To: Gay Group of Companies **Project No.:** 26018
Address: 55 King Street East, **Date:** September 18, 2026
 Bowmanville, ON L1C 1N4
Attention: Lawson Gay
Project Name: Bowmanville Health Centre
 CT & Radiology Clinic 4 Storey Building Expansion

Project: Bowmanville Health Centre
CT & Radiology Clinic 4 Storey
Building Expansion

The following information supplements and/or supersedes the bid documents issued on September 08, 2026.

Addendum No. 1

DRAWING:
**4th FLOOR FRAMING
PLAN**

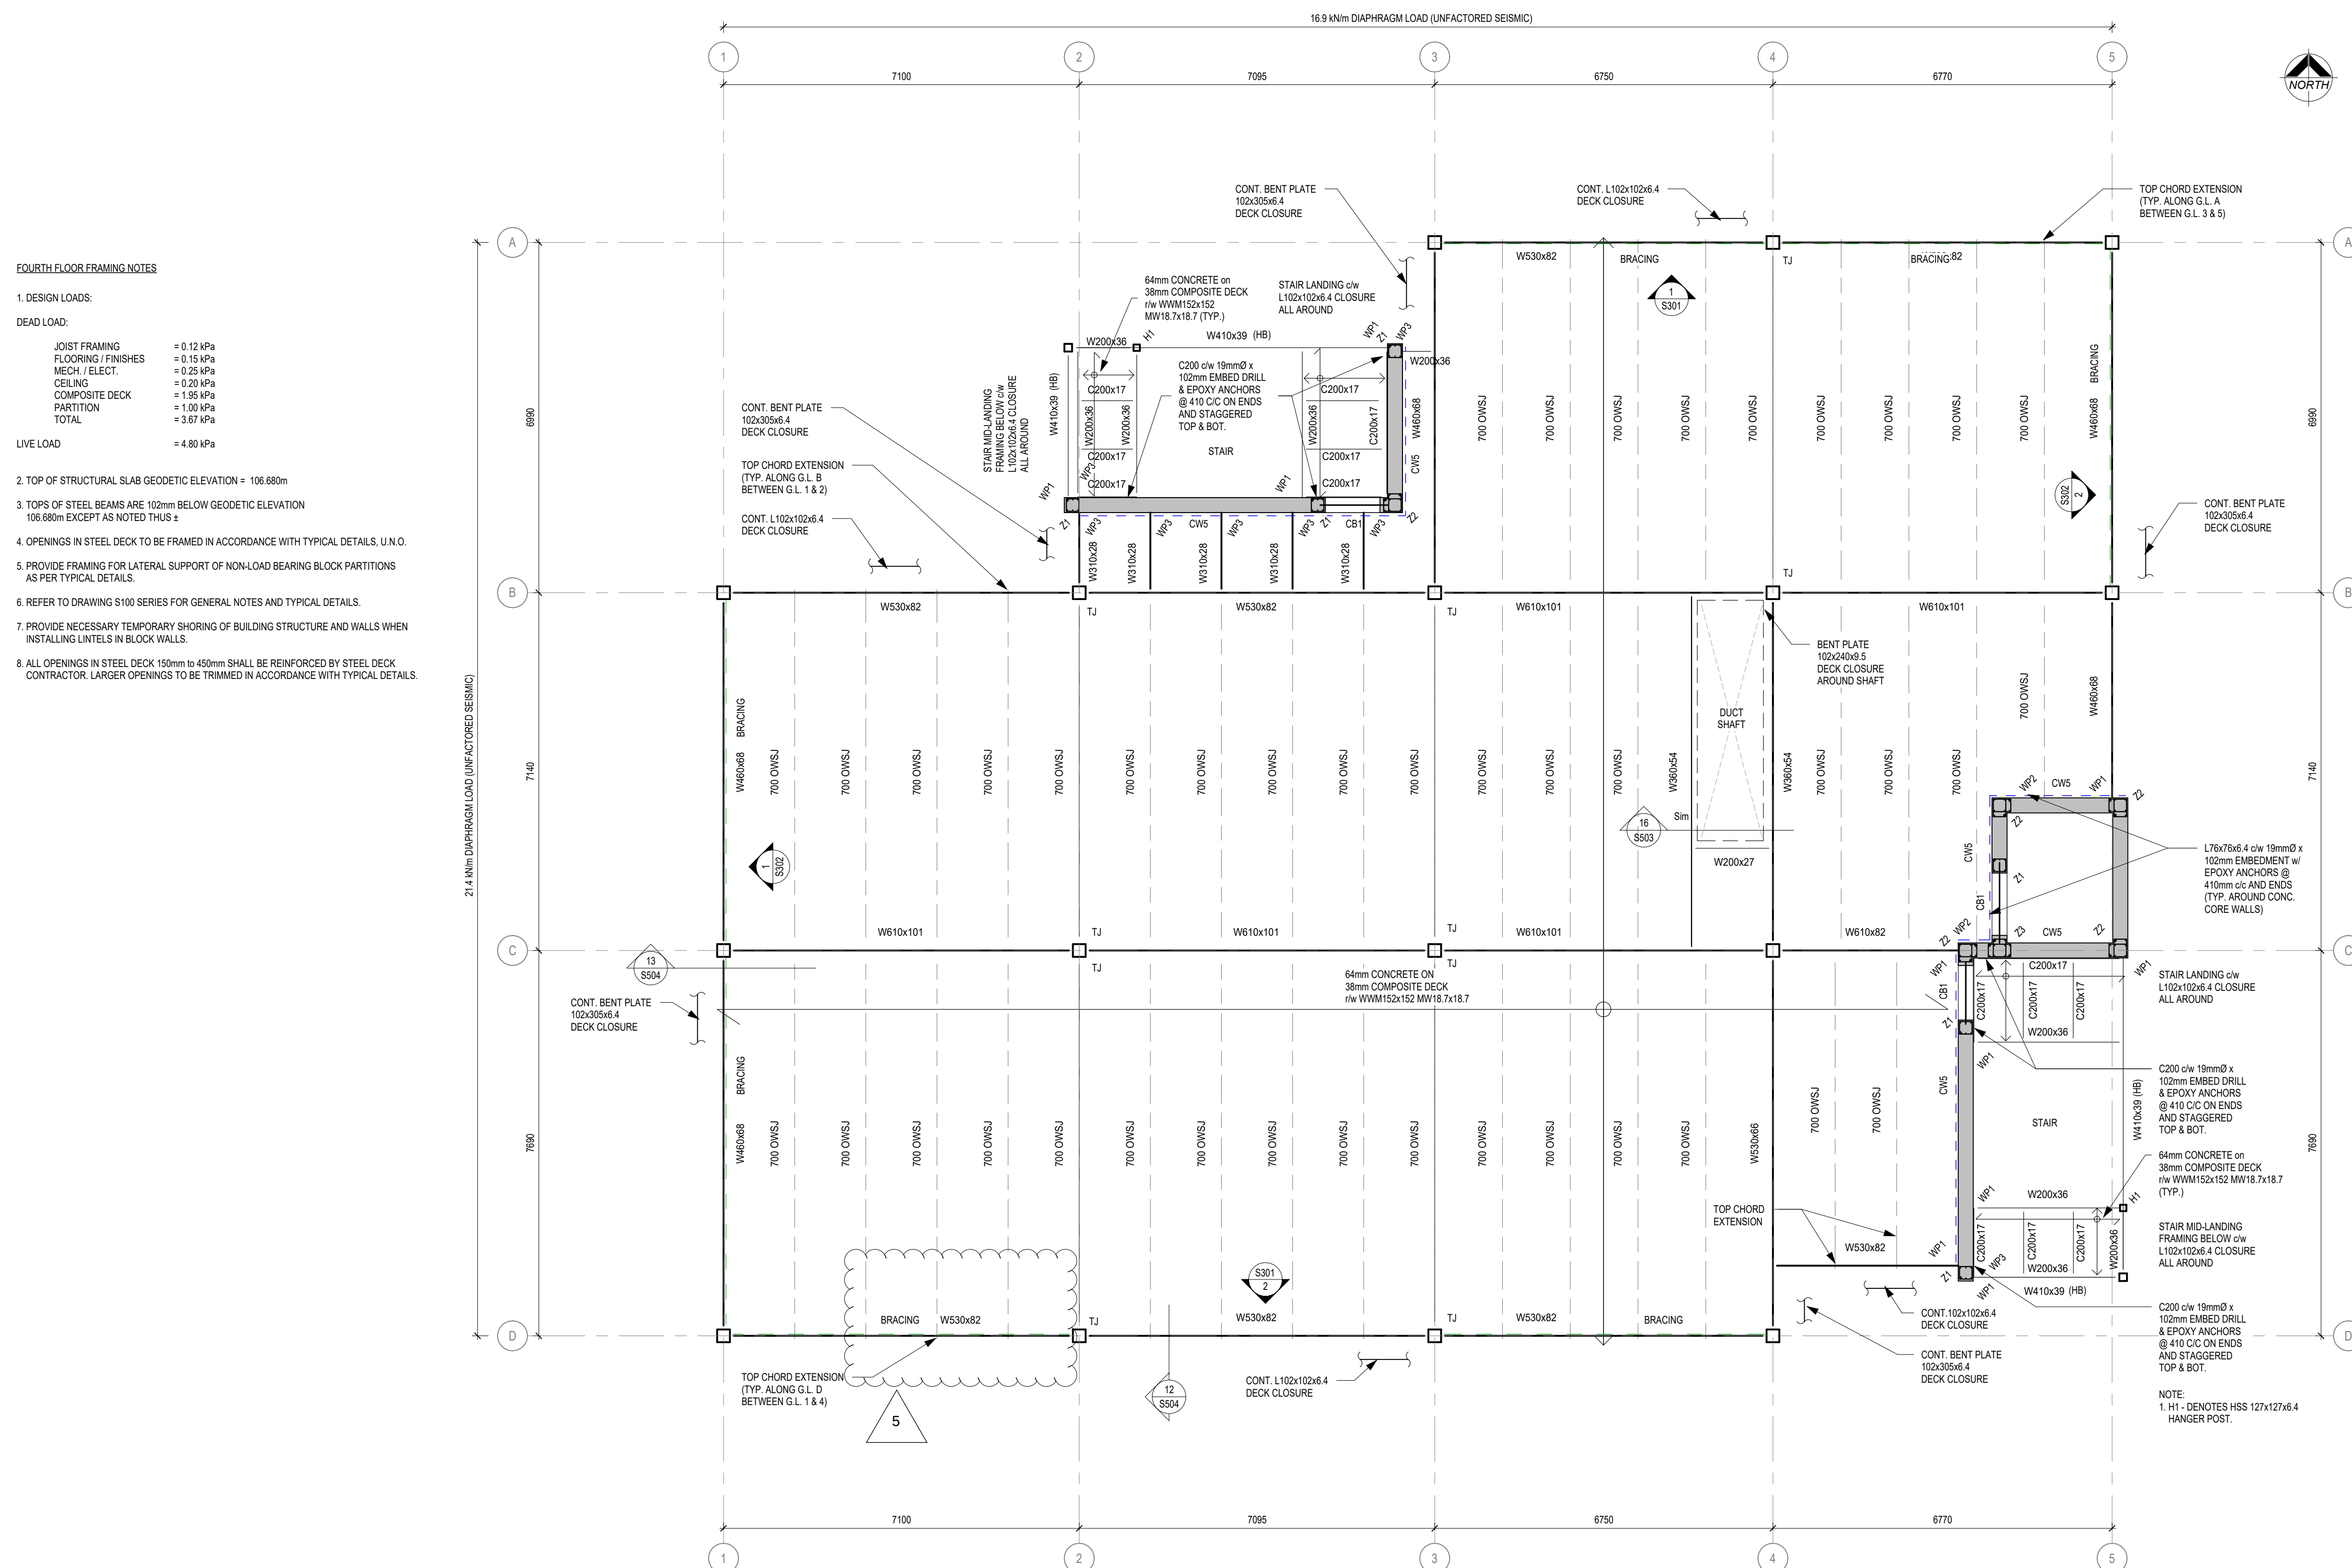
1.1 DRAWING NO. S203, S204, S205 (reissued)

.1 See as clouded.

- 1.5 Question: Please confirm the size of beam is W530x82 online D / 1 to 2, also Line D / 3 to 4. This applies from 2nd to 4th floors.

Answer: ***Yes, the size of beam is W530x82 online D / 1 to 2, also Line D / 3 to 4. This applies from 2nd to 4th floors. Refer to updated drawing sheet- S203, S204, S205***

DRAWING:
SLAB EDGE DETAIL FOR
BRICK WALL SUPPORT

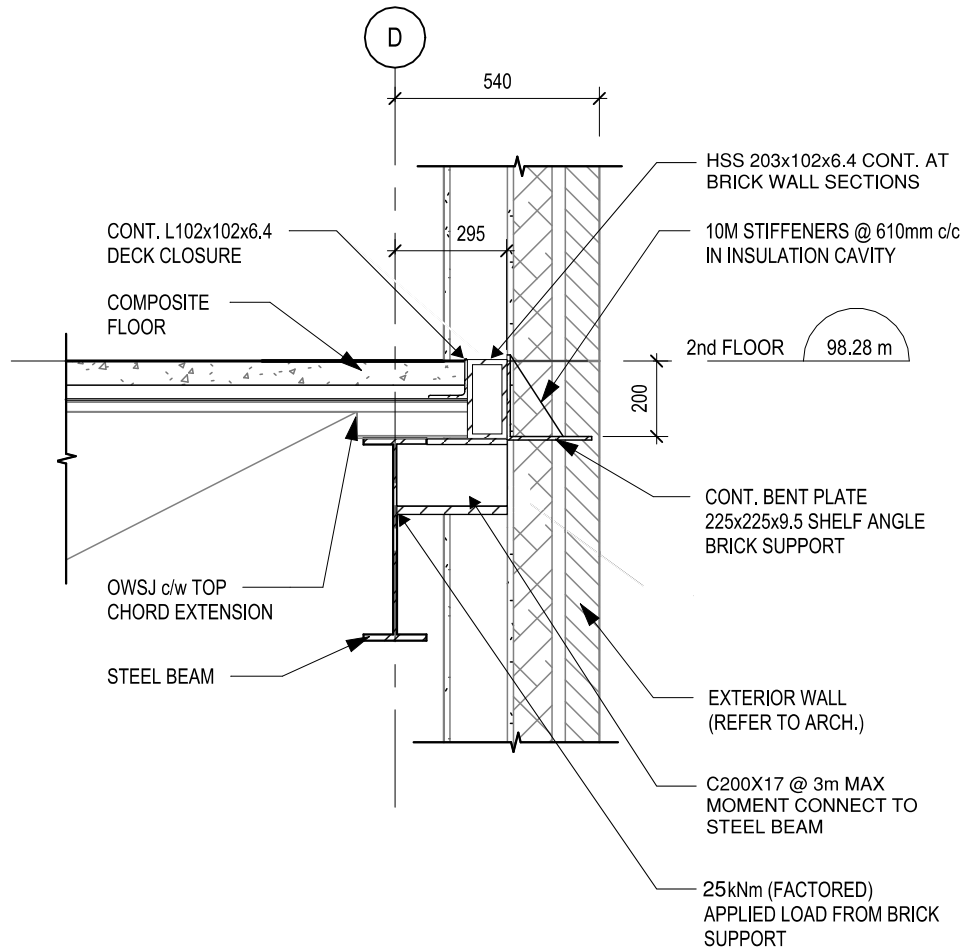
1.2 DRAWING NO. SKS-01

.1 Floor edge section detail at Level 2, for the brick wall location along Gridline (GL) D, Cx, B and A.

- 1.4 Question: The 2nd floor plan, S203 – Bowmanville Health Centre, along line D shows sections 1, 2 and 3/S503. Sections 1 and 2/S503 show a bent plate for brick support. Section 3/S503 shows angle behind the glazing. Drawing A203 gives dimensions for both the glazing and brick locations. These are not continuous as is inferred on S203. Where the glazing is from grid to back of angle is 180 – see 11/A420, attached.
Where the brick is from grid to back of angle is 194 on architectural drawings according to wall type W2. The structural sections shows 295 – this needs to be verified which is correct.
If we keep the trim angle at 180, the bent plate can be welded onto it where the brick is. This will keep the slab edge in a straight line.
It would appear that this applies all around the 2nd floor.
Let me know how you want this done in order to give a more accurate quote.

Answer: ***To simplify the floor edge at Level 2 along GL D, Cx, B and A, floor edge to be 180 away from GL (in both spandrel panel and brick location) and attached detail sketch (SKS-01) to be implemented at brick wall locations.***

The slab edges along GL 1, 2, 3, 4 and 5 stay as detailed in the original package.

SITE SERVICING PLAN

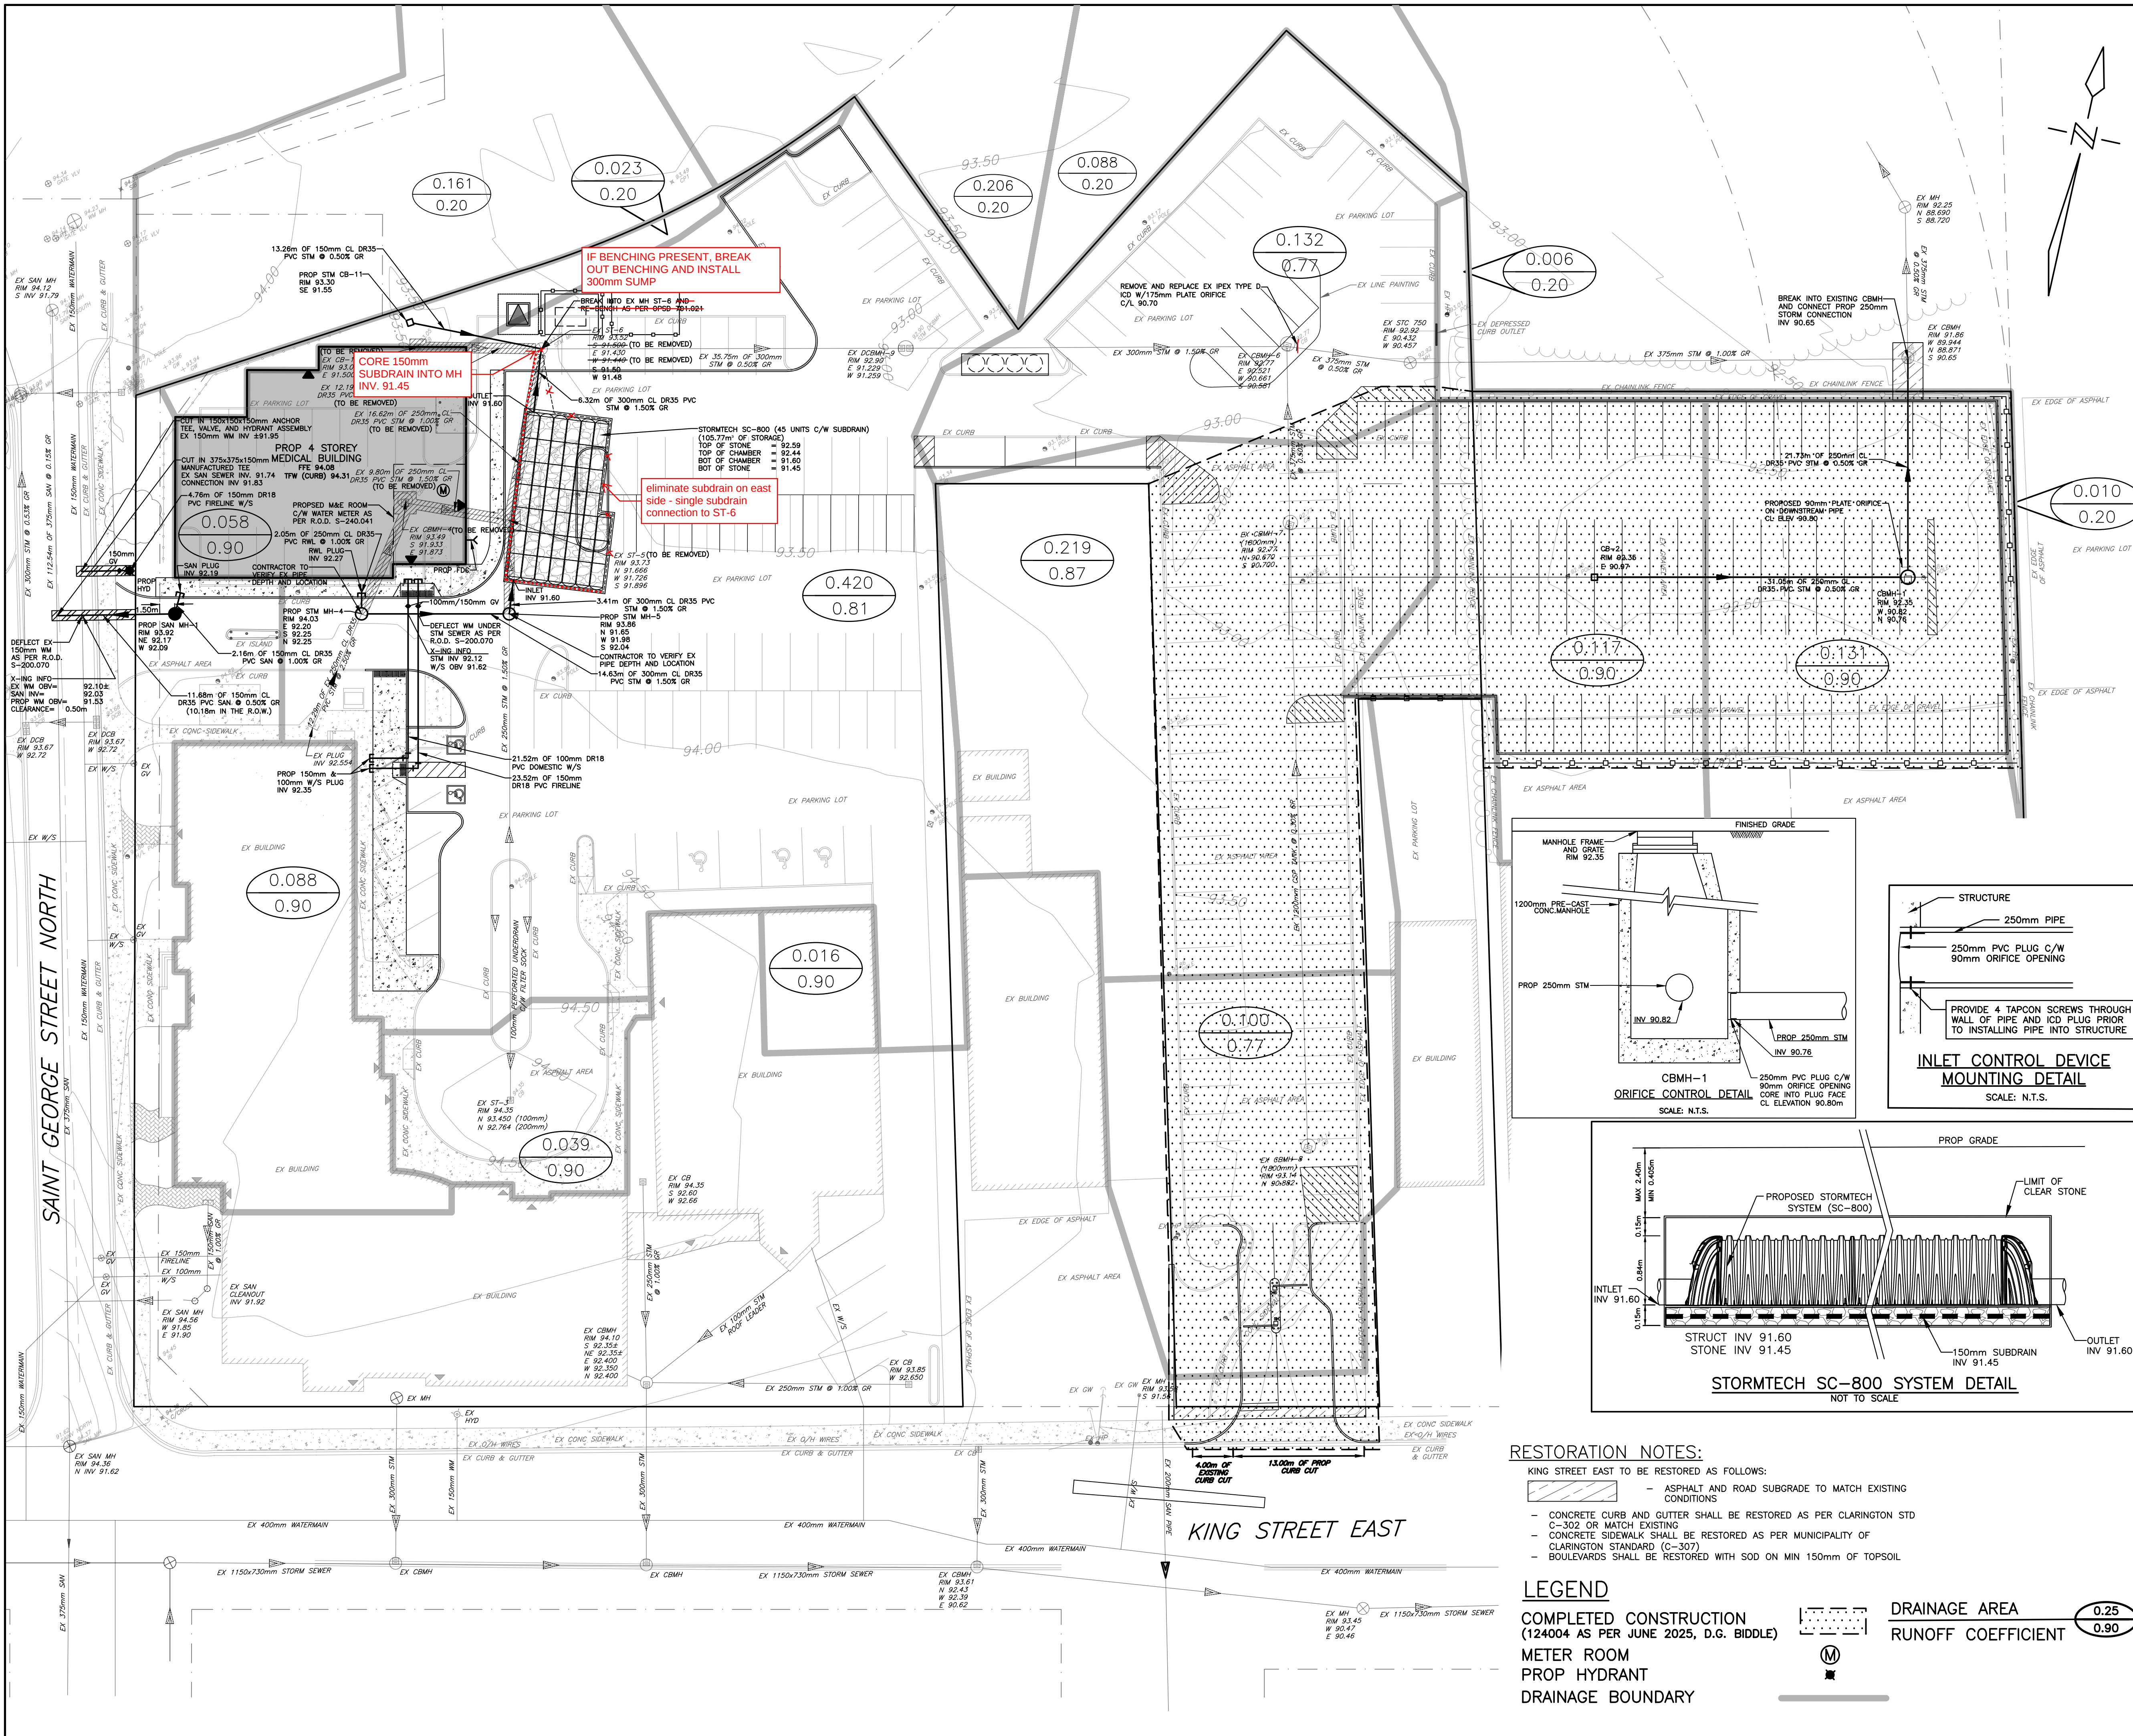
- 1.6 Question: Please confirm if the existing type of pipe that the sanitary sewer within Saint George St, N. noted to cut-In 375 x150mm dia. tee is?

- 1.8 Question: There is a 150mm Subdrain specified around the perimeter of the StormTech SC-800 to be installed at an elevation of 91.45 but the outlet to existing ST-6 is noted as 91.60, please provide connection detail and confirm that this is intended to remain submerged ie. 150mm below the outlet elevation?

Answer: ***(From Civil Consultant) There is no publicly available record of the existing sanitary sewer material. Contractor to verify material ahead of construction.***

Answer: ***(From Civil Consultant) The 150 mm subdrain is intended to drain the base stone beneath the StormTech SC-800 system to existing MH ST-6 and shall be independent of the storm pipe connection. The subdrain is to be cored into the existing MH ST-6. The base stone will drain based on the east outlet elevation of the existing MH (EL. 91.43), rather than the noted storm pipe outlet elevation of EL. 91.60. All connections shall be parged water-tight.***

We are assuming the existing STM MH is benched. Rather than re-benching the MH, we recommend breaking out the existing benching, cleaning and parging the base of the MH, and maintaining a sump to allow the subdrain to discharge and drain the base stone. Accordingly, the subdrain is intended to remain below the storm pipe outlet from the stormtech and will discharge to the sump within the existing MH.

DEFLECTION OF WATERMAIN OVER AND UNDER SEWER

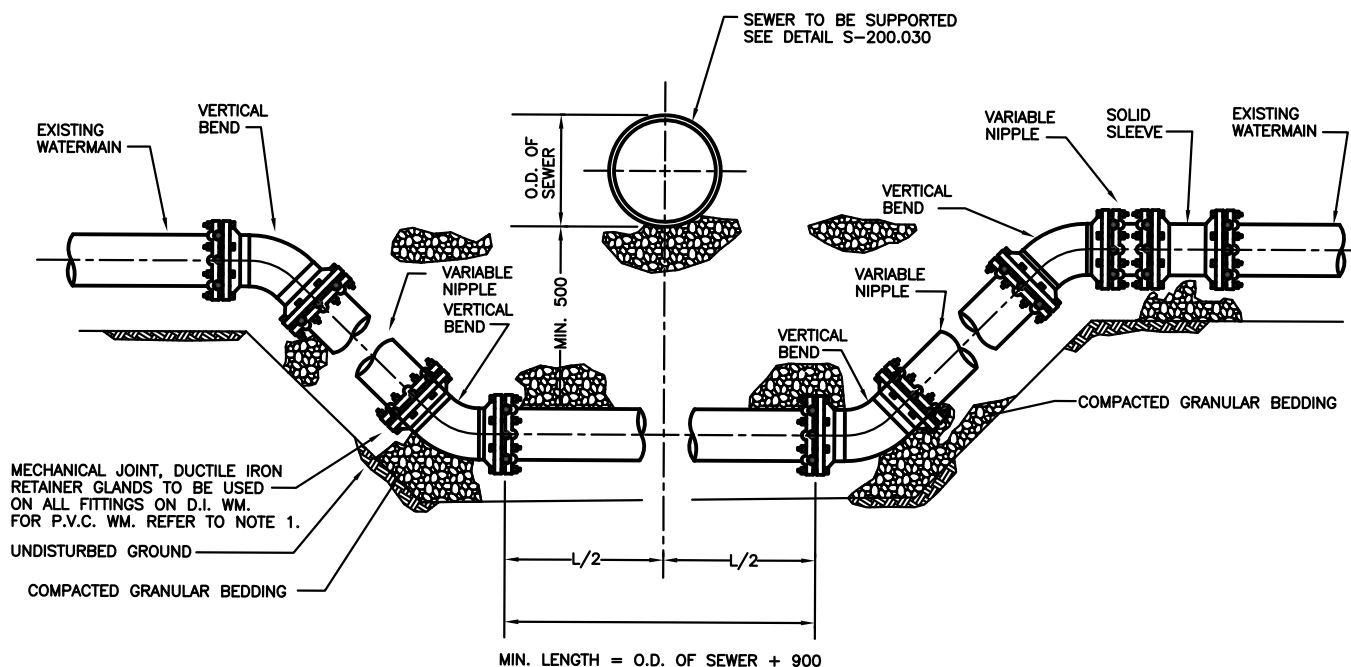
- 1.7 Question: Please confirm if the existing type of pipe that the watermain within Saint George St, N. noted to cut-In 150 x150mm dia. tee, I and to in order lower watermain to install sanitary?

Answer: ***(From Civil Consultant) Based on the record drawings (attached) the watermain is 150mm PVC, and yes, the watermain is conflicting with the sanitary connection. Watermain to be deflected per RMD Std. S-200.070 (attached).***
